REQUEST FOR INFORMATION DATE: April 11, 2017 NO.: RFI-513

Project Name: 15051-Webster University Interdisciplinary Science Building Project No.: 15051

Subject: fire alarm – door hold release

E0102.B

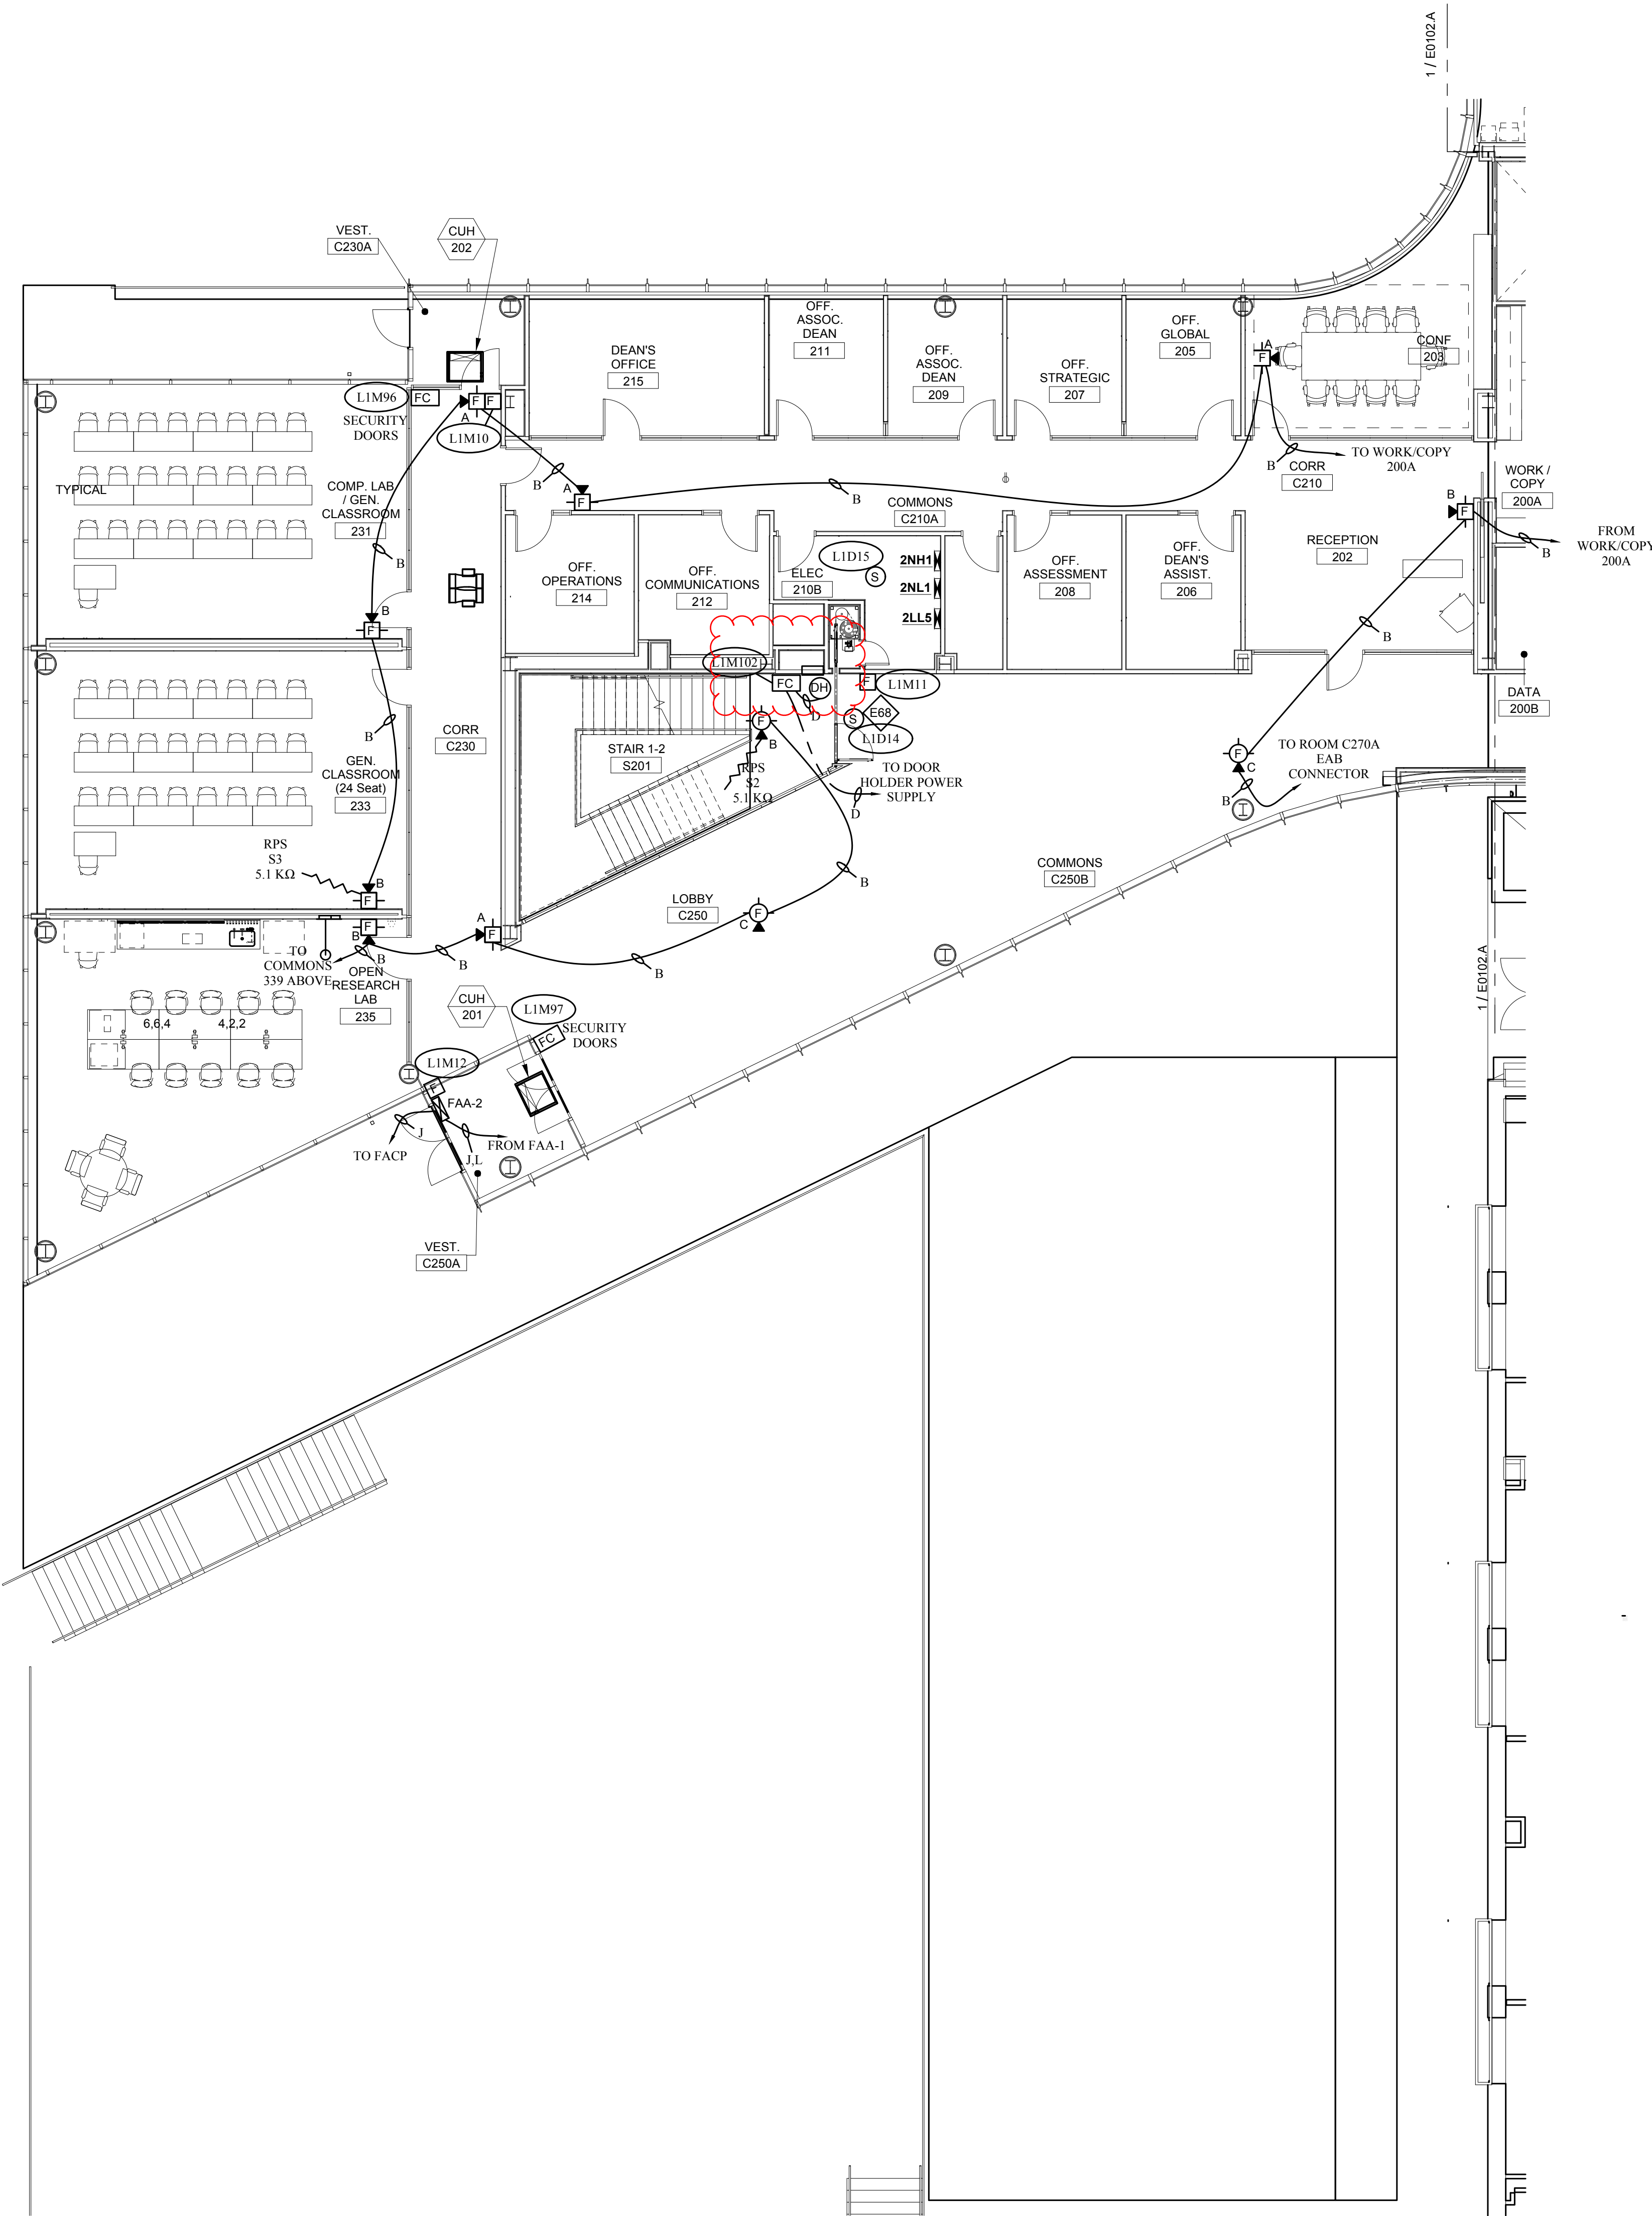
See attached drawings. For the clouded areas on E1010.B/E0102.B/E0103.B/E0104.B. Will all of these door holders release at the same time in the event of a fire or on individual alarms per floor?

All doors to release upon a general alarm.
